ENCANTO

FIRE MASTER PLAN

TRACT 13343 - LOT 13

OCFA SERVICE REQUEST 201232

SHEET F-1 OF 1

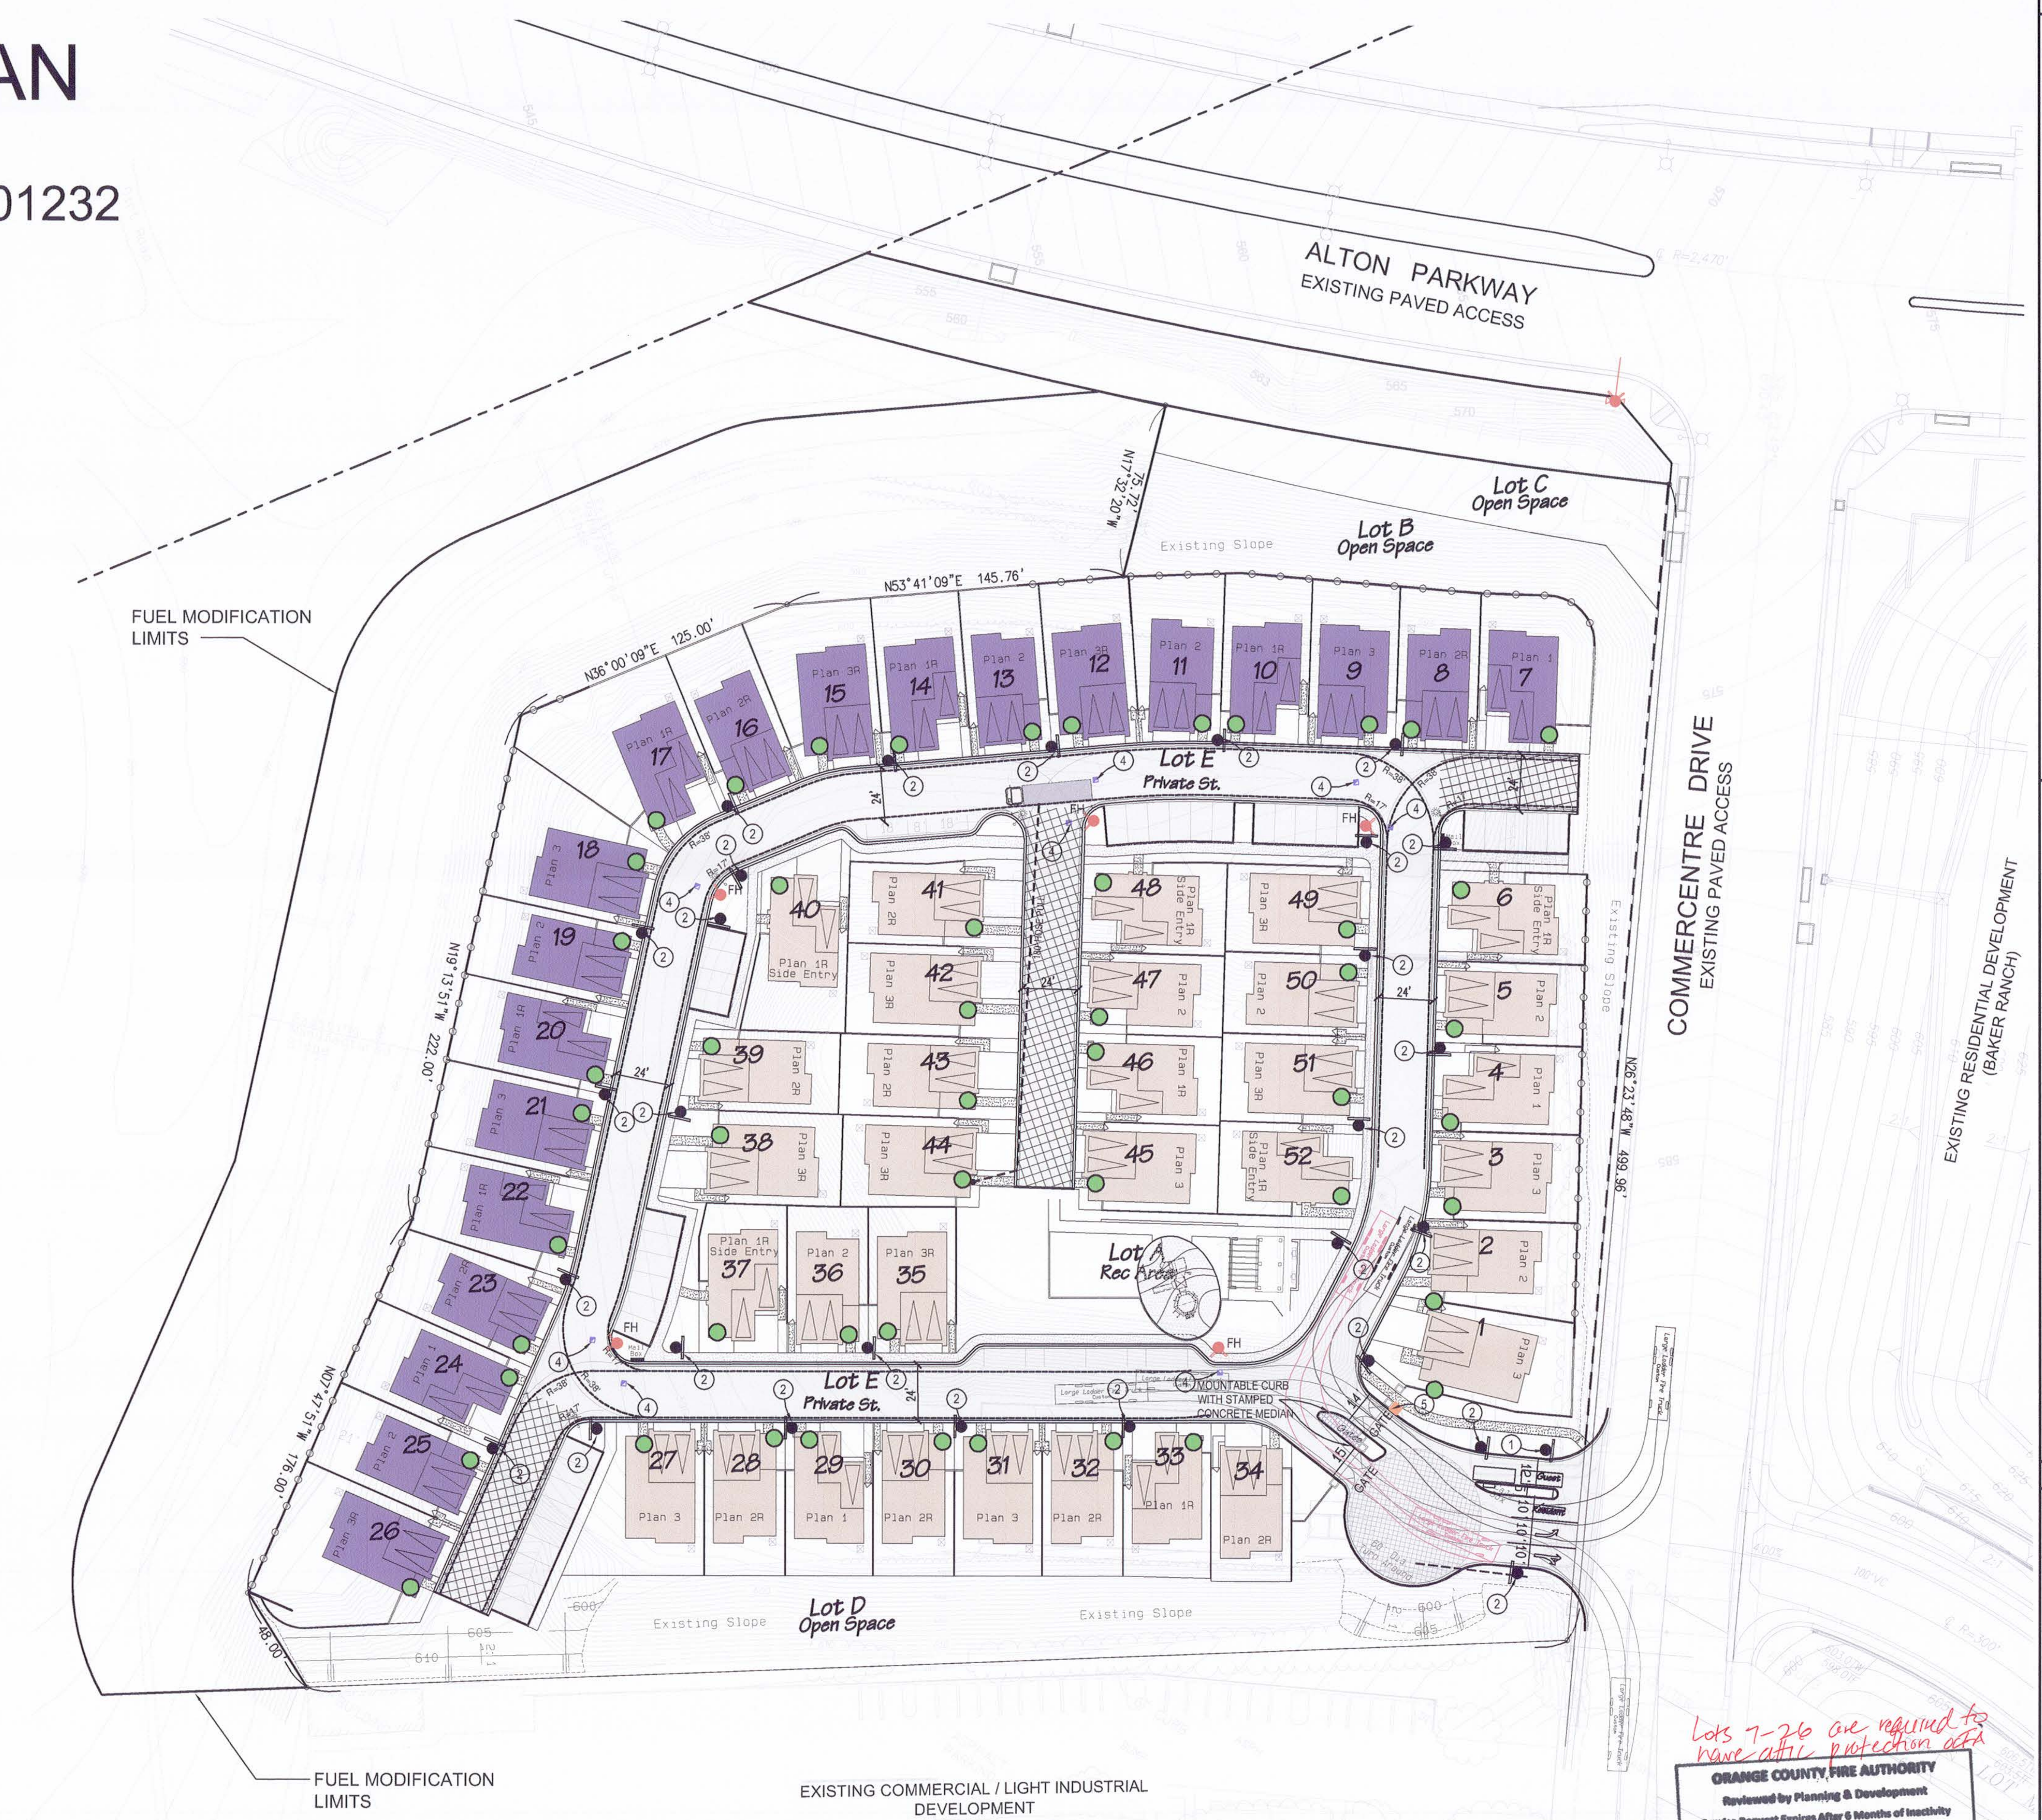
Lots 7-26 are required to have attic protection ocfa
